SUBDIVISION REVIEW SHEET**CASE NO.:** C8-2022-0352.0A**COMMISSION DATE:** February 28, 2023**SUBDIVISION NAME:** 220 Ralph Ablanedo Drive**ADDRESS:** 220 Ralph Ablanedo Drive**APPLICANT:** Sierra Holloway (Kimley-Horn)**AGENT:** Kevin Goradia, Grace Nicholas**ZONING:** CS-CO (General Commercial Services) **NEIGHBORHOOD PLAN:** N/A**AREA:** 3.99 Acres (173,804 sf)**LOTS:** 1**COUNTY:** Travis**DISTRICT:** 2**WATERSHED:** Onion Creek**JURISDICTION:** Full Purpose**SIDEWALKS:** Sidewalks will be constructed along Ralph Ablanedo Drive and Peaceful Hill Drive.**VARIANCE:** N/A.**DEPARTMENT COMMENTS:**

**CITY OF AUSTIN –DEVELOPMENT SERVICES DEPARTMENT
SUBDIVISION APPLICATION – MASTER COMMENT REPORT**

CASE NUMBER: C8-2022-0352.0A
 UPDATE: U0
 CASE MANAGER: Nicholas Coussoulis

PROJECT NAME: 220 Ralph Ablanedo Drive
 LOCATION: 220 RALPH ABLANEDO DR

Property Profile

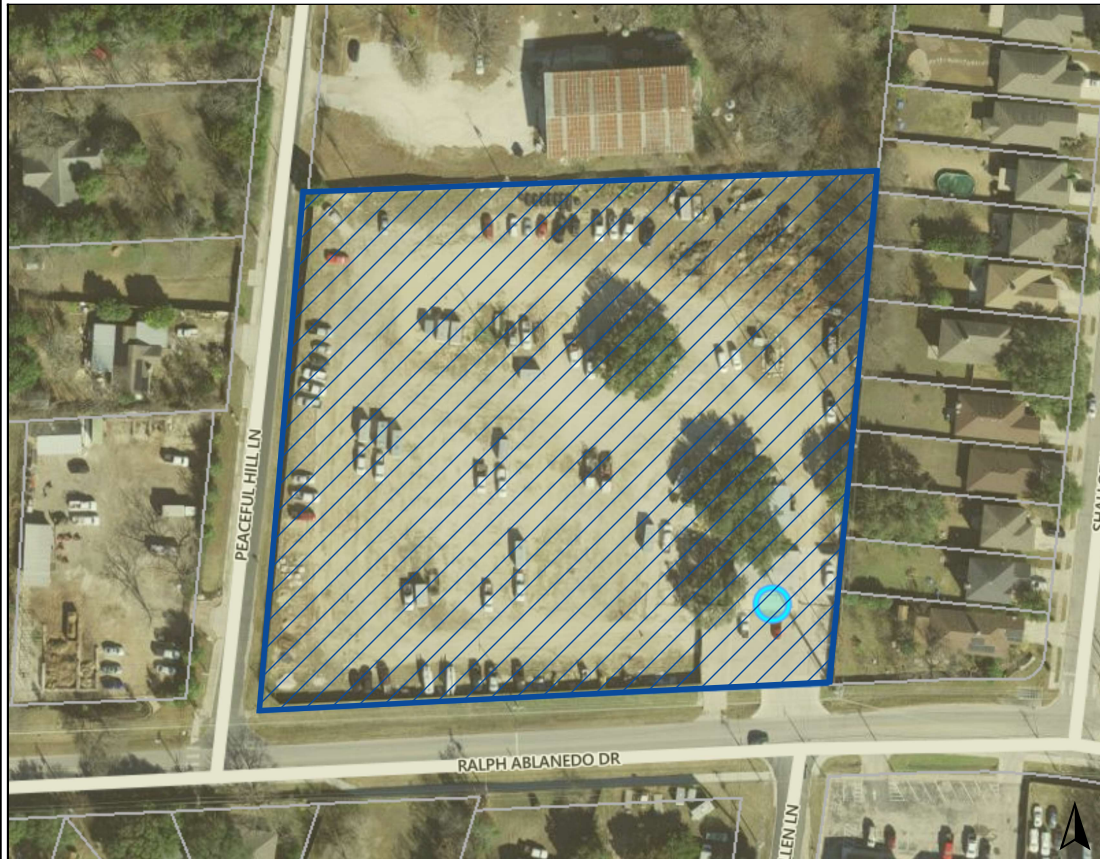
AD2: **W DITTMAR RD** is the correct street name for this project in the vicinity map

AD3: Please update label for **W SLAUGHTER LN** the directional W must be included in the vicinity map

NOTE: W DITTMAR RD is incorrectly labeled as W DITTMAR DR
